TfNSW Reference: SYD26/00611/01
DPHI Reference: SSD

**REQUEST FOR SECRETARY'S ENVIRONMENTAL ASSESSMENT REQUIREMENTS (SEARS)
MIXED USE DEVELOPMENT
4-16 MONTGOMERY STREET, KOGARAH**

Preliminary Planning Proposal – 4-16 Montgomery Street, Kogarah

Figure 1 – Section with Proposed heights

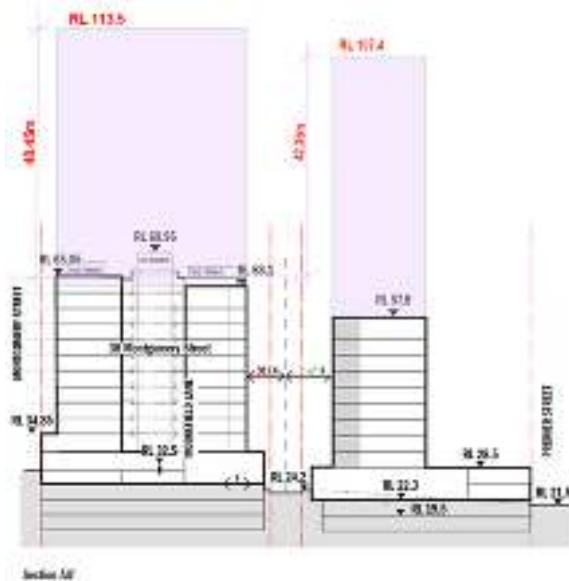
There is a current disconnect between the existing development and the proposed building heights. It is considered that the proposal is not a harmonious fit and compatible with the existing and planned context, nor does it enhance relationship with the lower-scale heritage building.

Figure 1 and 2 below have been roughly drawn to demonstrate the transition in heights for the proposed development.

The proposed building heights are not consistent with the Kogarah's distinctive identity and character that is required to be maintained under Part 8.1.3 of Georges River Development Control Plan (GRDCP) by ensuring that:

As previously stated, the proposal does not provide appropriate transition to the Grace Chinese Christian Church (heritage Church). For the 8-storey building

adjacent to the heritage Church, the horizontal separation / distinction between the tower and the 2 storey podium is achieved by providing a modest setback to the 3rd storey. This does not provide an appropriate transition in scale.

As stated in previous comments, applying angular planes and appropriate building separation / setbacks and lowering the building heights should be considered to provide a better transition from the higher scale buildings to lower scale existing buildings.

Figure 3 – Sketch of possible alternate access arrangements for Moorfield Lane

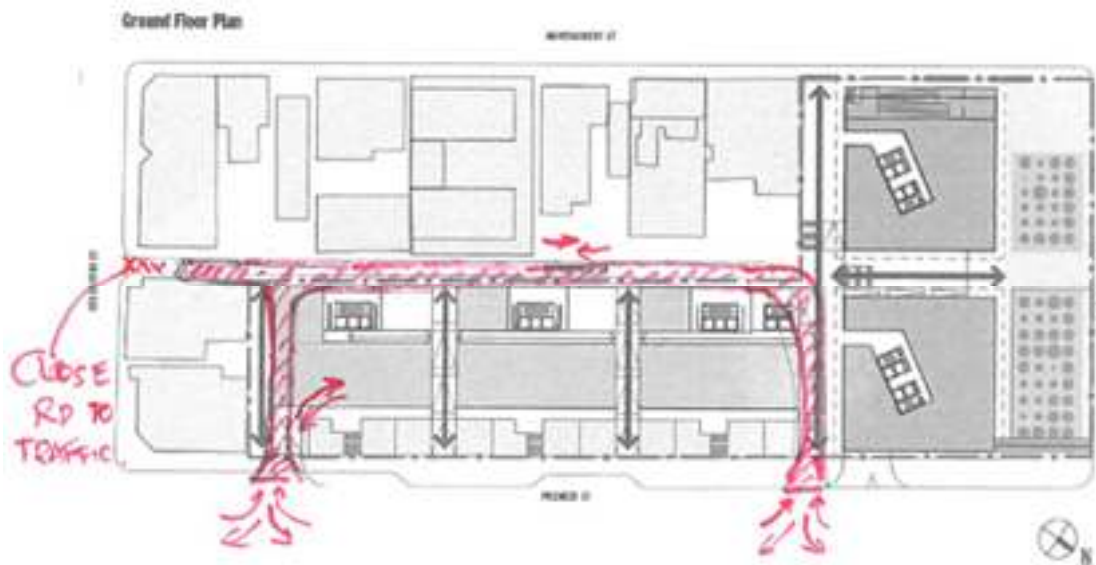
Closing Moorfield Lane to vehicle entry/exit at Kensington Street will reduce the issue of vehicle queuing on Kensington Street. However, property No's 44,46 and 50 Montgomery Street and No. 1 Kensington Street have their waste and recyclables collected from the lane. Closing the lane will impact the collection and the matter will need to be further investigated as part of the Planning Proposal.

Having regard to the above and to point 4 below, it is recommended that consideration be given an alternate vehicle access to and from the site as shown in principle in the image below. This could include reallocating the currently proposed north-west access to within the Laneway itself.

The proposed widening of the road reserve and carriageway in Moorfield Lane to make it two way will result in part of the carriageway being in the ownership of Council and part not owned by Council.
